CUP SITE PLAN LITCHFIELD AS SUBDIVISION

STAFF REPORT

PROJECT: Litchfield AIS

PURPOSE: To acquire a Conditional Use Permit allowing a major subdivision of the properties located at 900, 904 & 906 Homestead Road

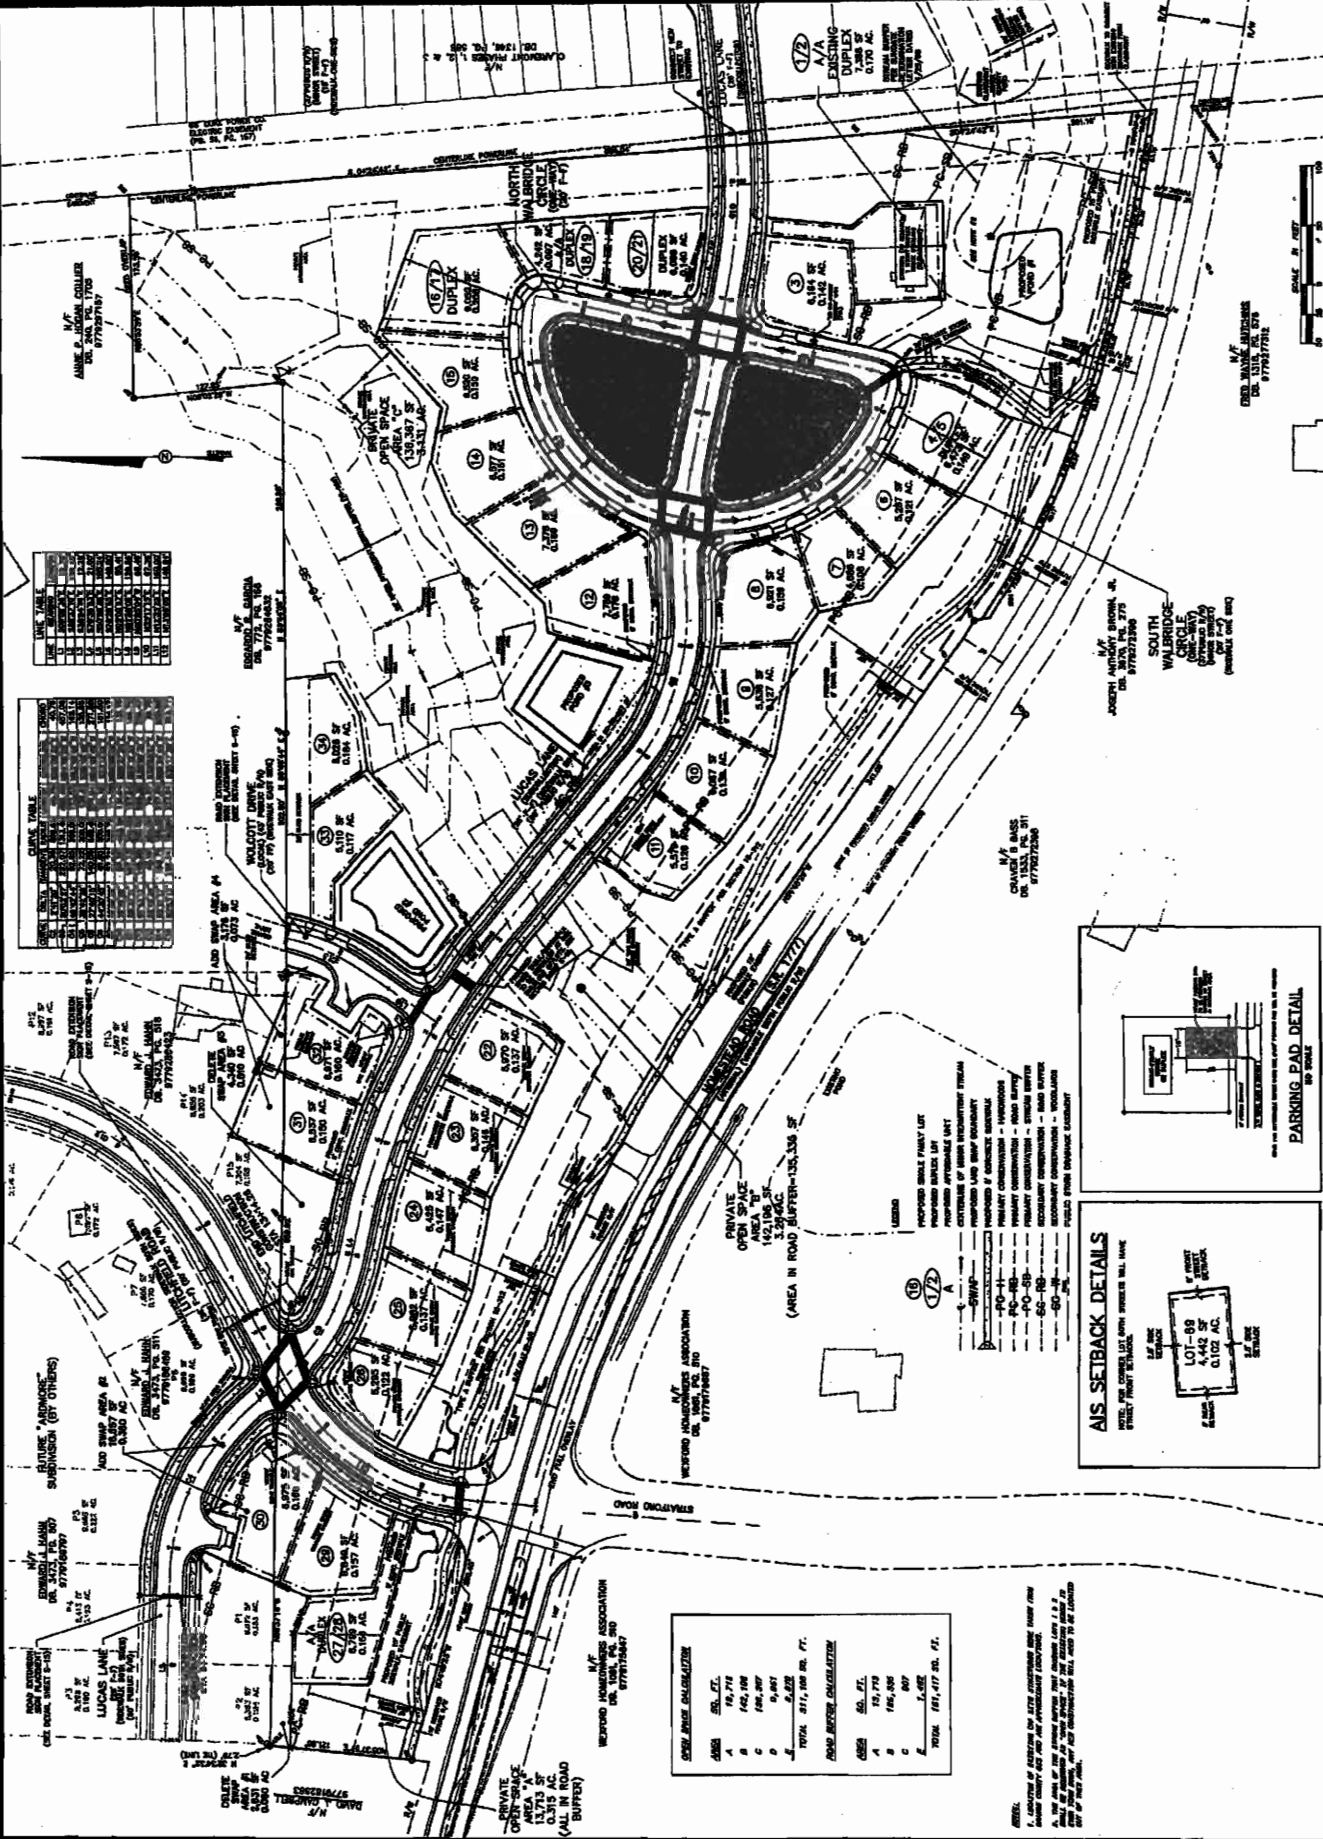
Note that the plans have a minor outstanding comment regarding the sidewalk detail that is addressed by the following condition.

A Type A screen is opaque from the ground to a height of six (6) feet with intermittent visual obstructions from the opaque portion to a height of at least twenty (20) feet. The attached plans do not show this screen and because of this the following condition is recommended:

- That, prior to Construction Plan approval, the sidewalk detail on the detail sheet is labeled and specifies that sidewalk thickness shall increase to a minimum of 6" thick where all driveways cross the sidewalk.

- That, prior to construction plan approval, the equivalent of a Type A screen be shown on the development side of the Homestead Road Buffer. Maintenance of this buffer is a continued condition of this permit.
